REVISED RESPONSE TO REQUEST FOR ADDITIONAL INFORMATION

APR1400 Design Certification

Docket No. 52-046

RAI No.: 182-8160
SRP Section: 03.07.01 – Seismic Design Parameters
Application Section: 3.7.1
Date of RAI Issue: 08/31/2015

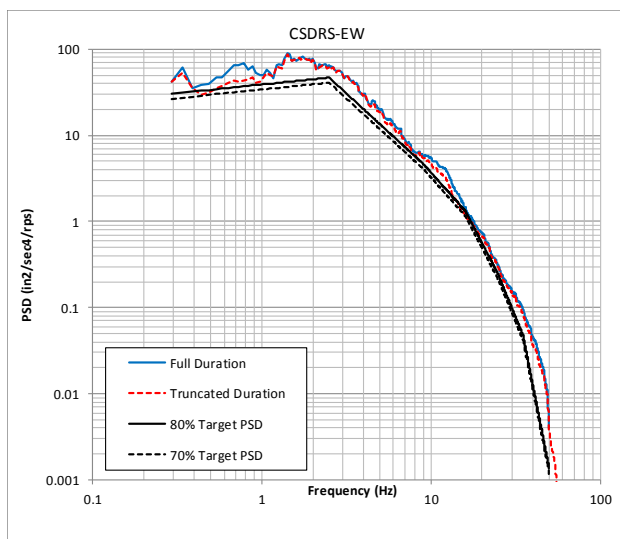
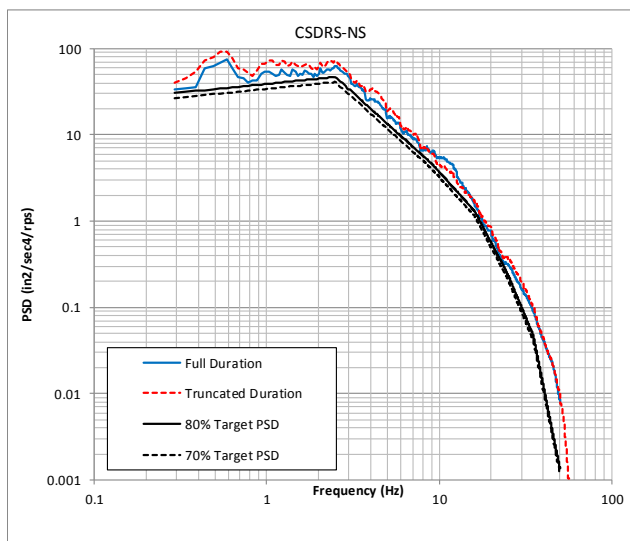
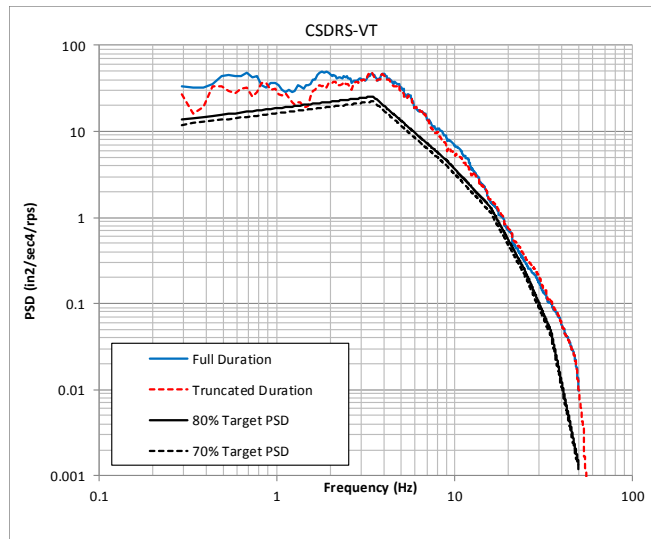
Appendices A and B of SRP 3.7.1 indicate that PSD should be estimated based on the strong motion duration. Therefore, the staff requests that the applicant provide a justification for the use of equivalent stationary strong-motion duration. Similarly, the applicant is requested to explain why the entire time histories were used in the Fourier transform. The use of the equivalent stationary strong-motion duration, which is shorter than the entire duration as shown in Figure 3-27 of APR1400-E-S-NR-14004-P, Rev. 1, together with the entire time history used in the Fourier transform, may overestimate the PSD for those frequencies that have very low magnitude but span the entire time history

As shown in Figure 22 through 24, it can be concluded that the use of full-duration time history and the corresponding 0% to 100% extended equivalent stationary duration

$T_e(100\%-0\%) = T(75\%-5\%)/0.7$ to compute the time-history PSD is a convenient and valid procedure to generate the time-history PSDs.

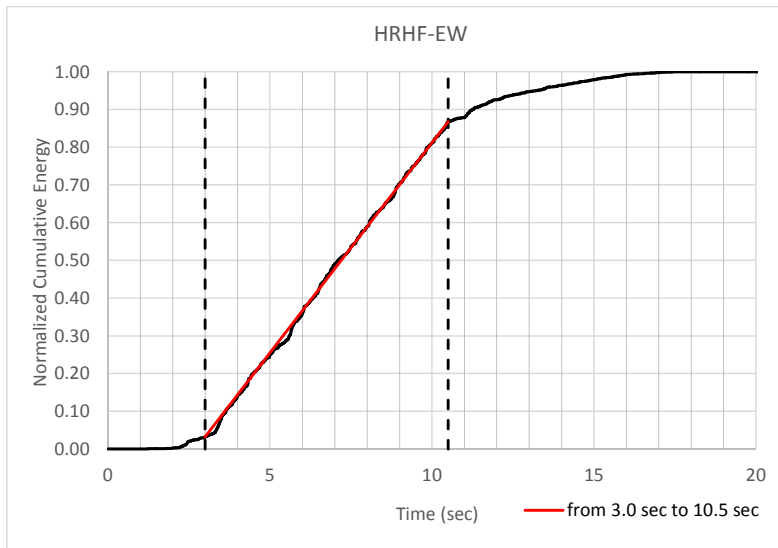
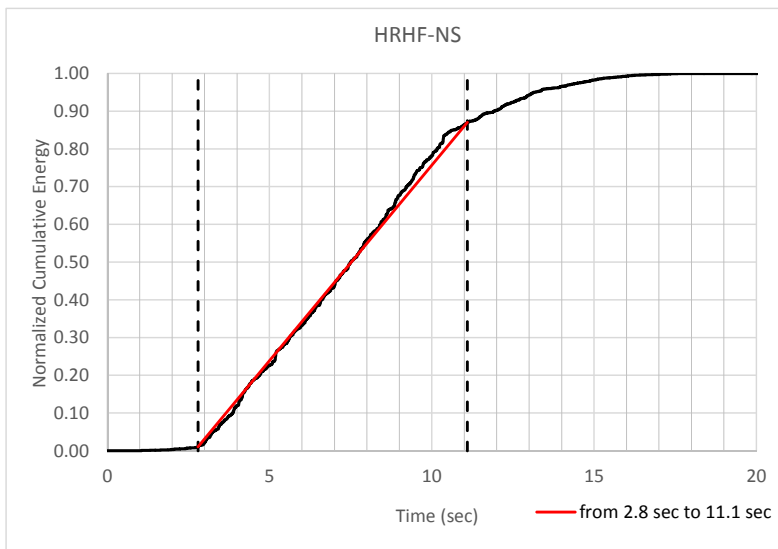
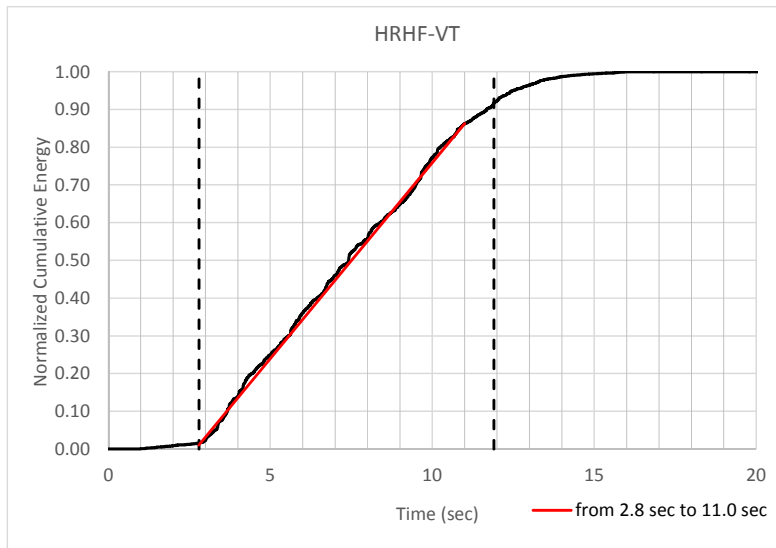
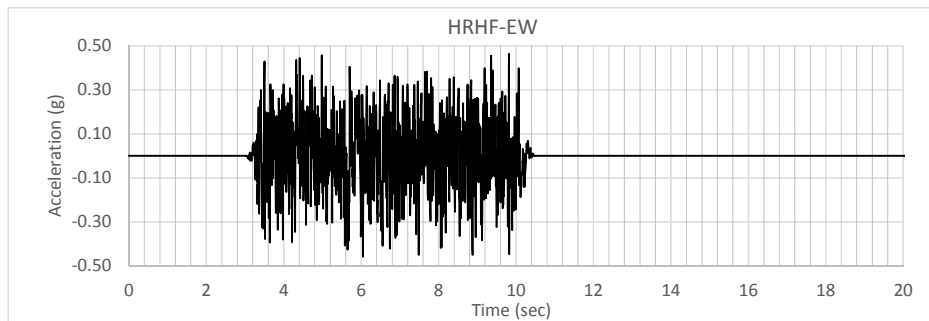
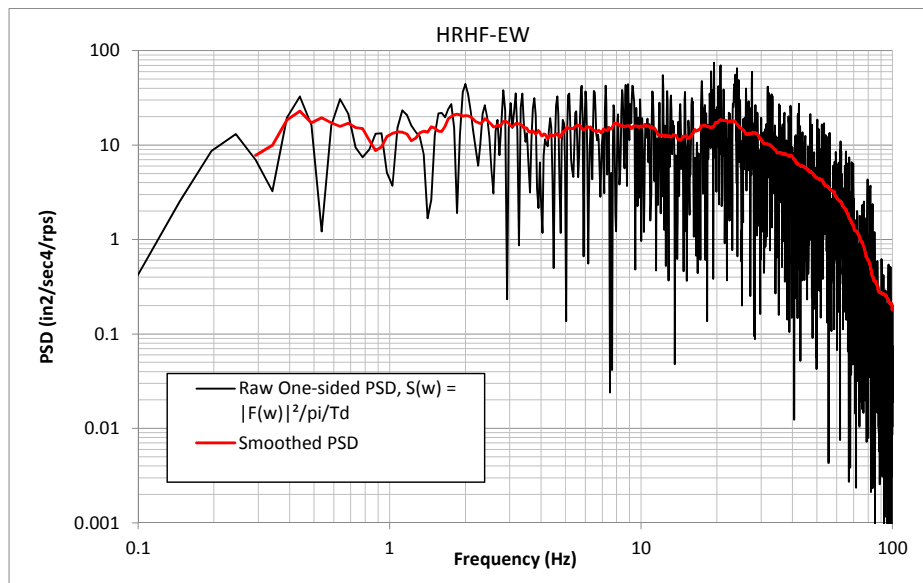
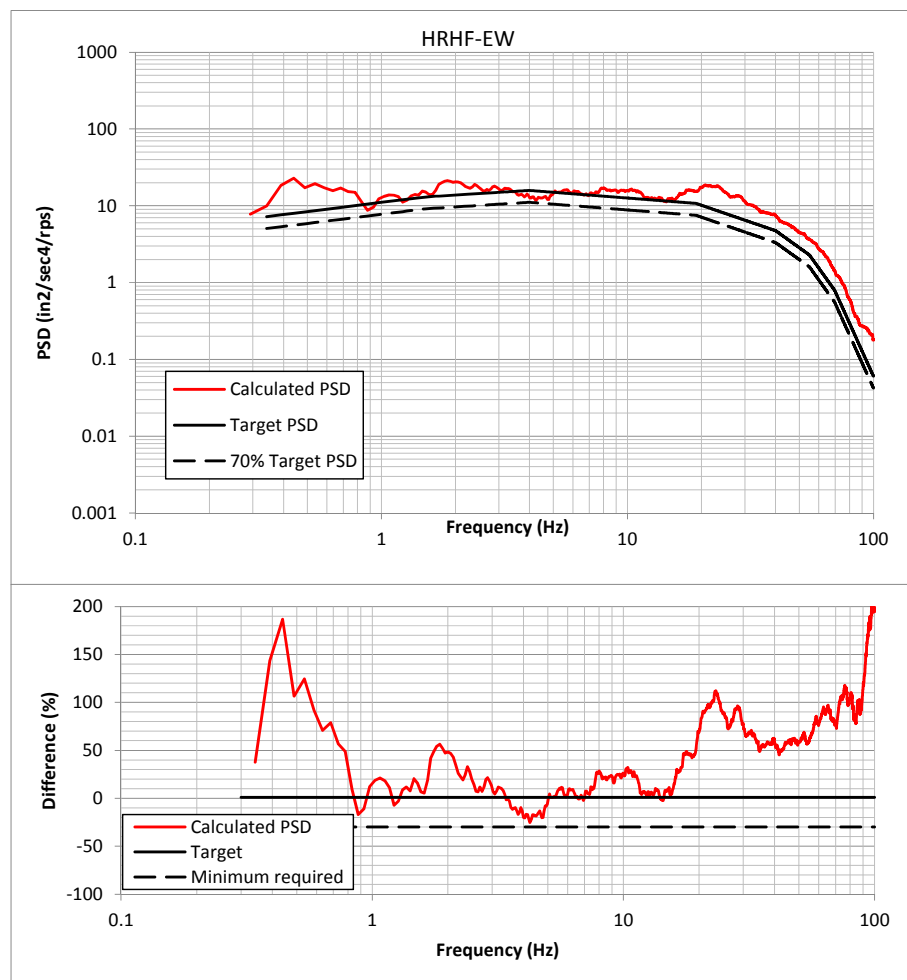
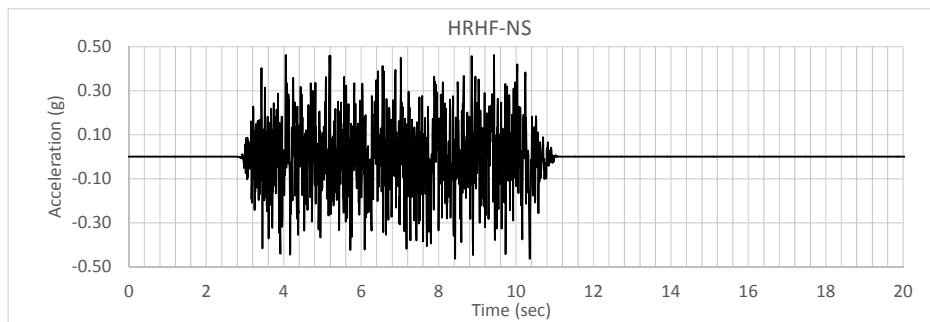
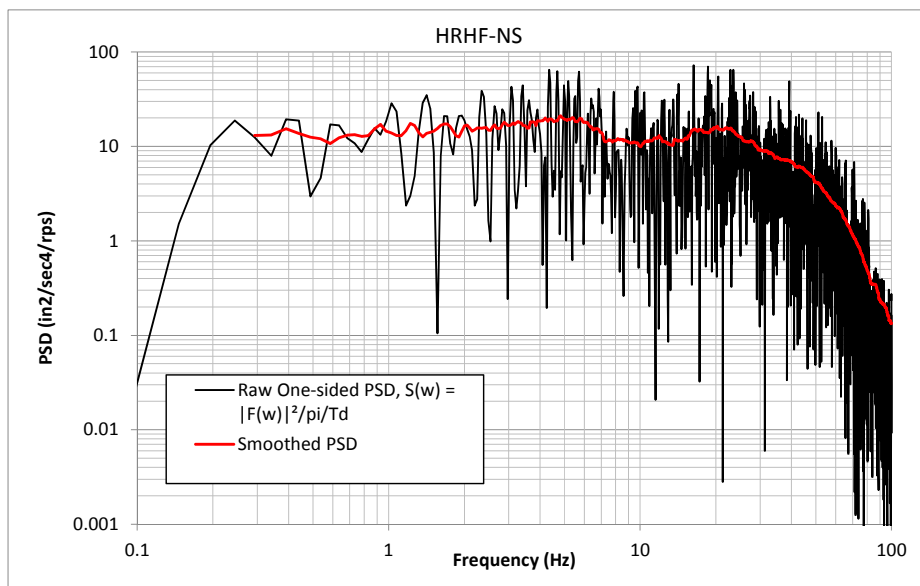
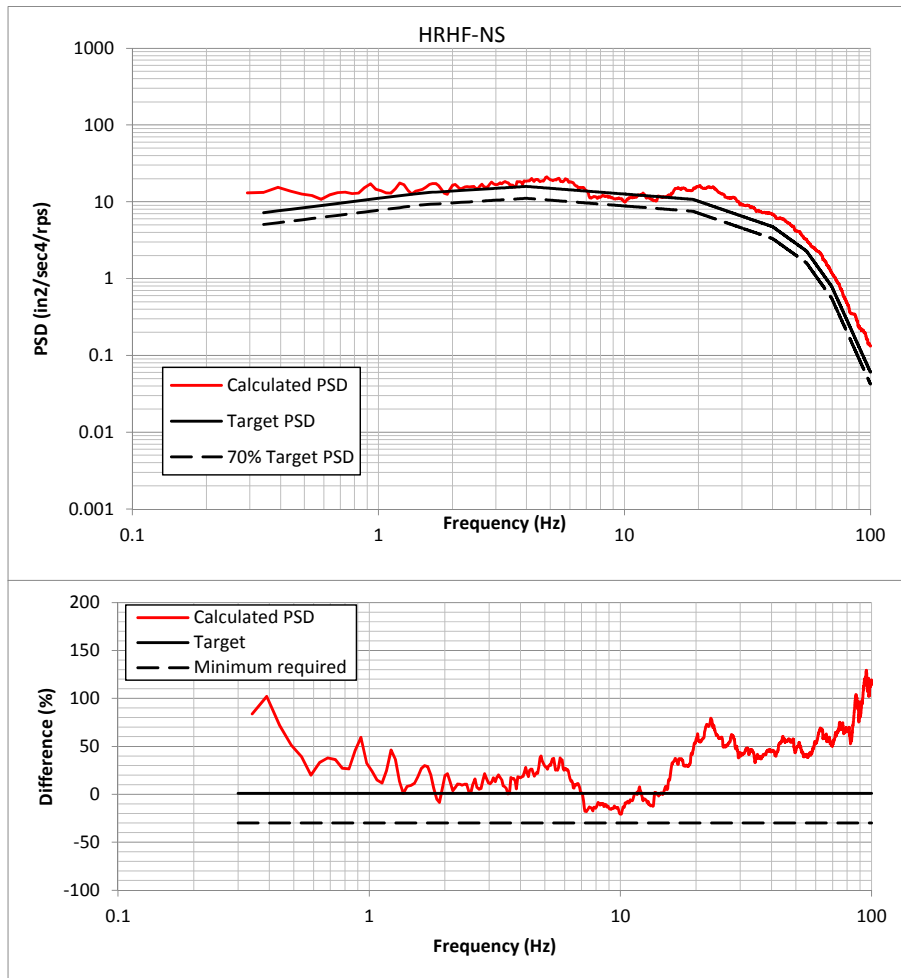
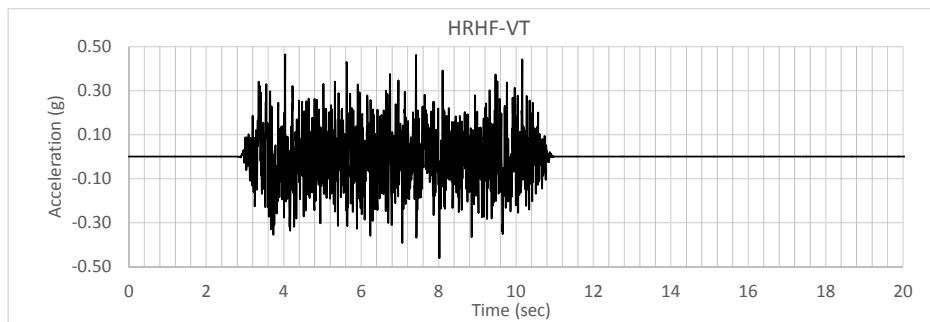
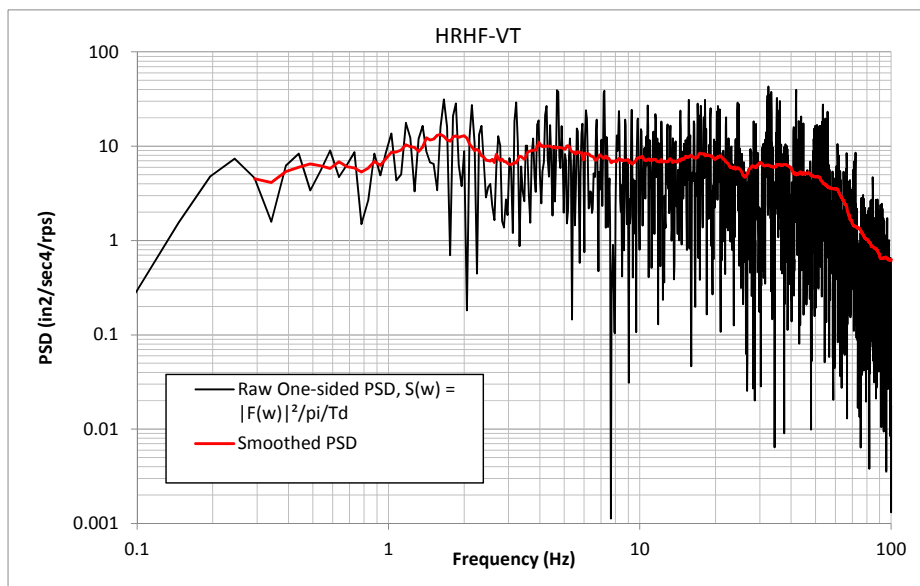
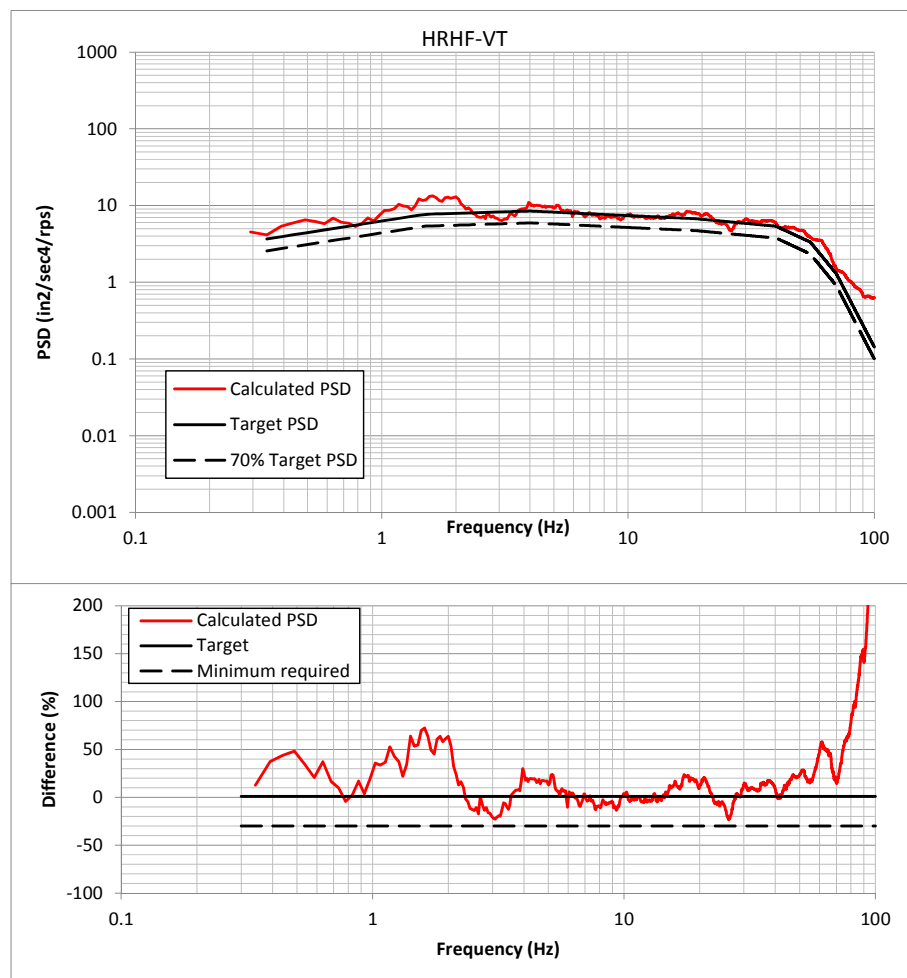
Section 3.5.3 of APR1400-E-S-NR-14004-P, Rev. 1, "Evaluation of Effects of HRHF Response Spectra on SSCs," describes the method used to calculate the PSD function from an acceleration time history. It utilizes an "equivalent stationary strong-motion duration" as the strong motion duration. The equivalent stationary strong motion is defined as the time for a P1-to-P2 rise of the cumulative Arias intensity, divided by (P2-P1). The applicant stated, "the equivalent stationary duration T_s for the entire time histories as determined from Eq. (3-3) is the duration over which the total energy of the time history is built up from 0 to 100 percent with the

constant slope S." In this statement, the parameters P1, P2, and S are not defined. As such, the applicant is requested to provide these three parameters for the three HRHF acceleration time histories. In addition, it appears that the PSD estimate is very sensitive to the choice of P1 and P2; for example a P1=0 and P2=100% will lead to an equivalent stationary strong-motion duration T_s equal to the total duration of the time history. As such, the applicant is also requested to provide a justification for the values of P1 and P2.

The PSDs for the HRHF RS compatible time histories are computed using the procedure which is described in response to Question 03.07.01-3 (a) as shown in Figure 25 through 36. The PSDs for the HRHF RS compatible time histories satisfy requirement of Appendix B of SRP 3.7.1, Rev. 4 as shown in Figure 30, 33, and 36. The comparison of PSDs between using full duration and truncated durations are shown in Figure 37 through 39.
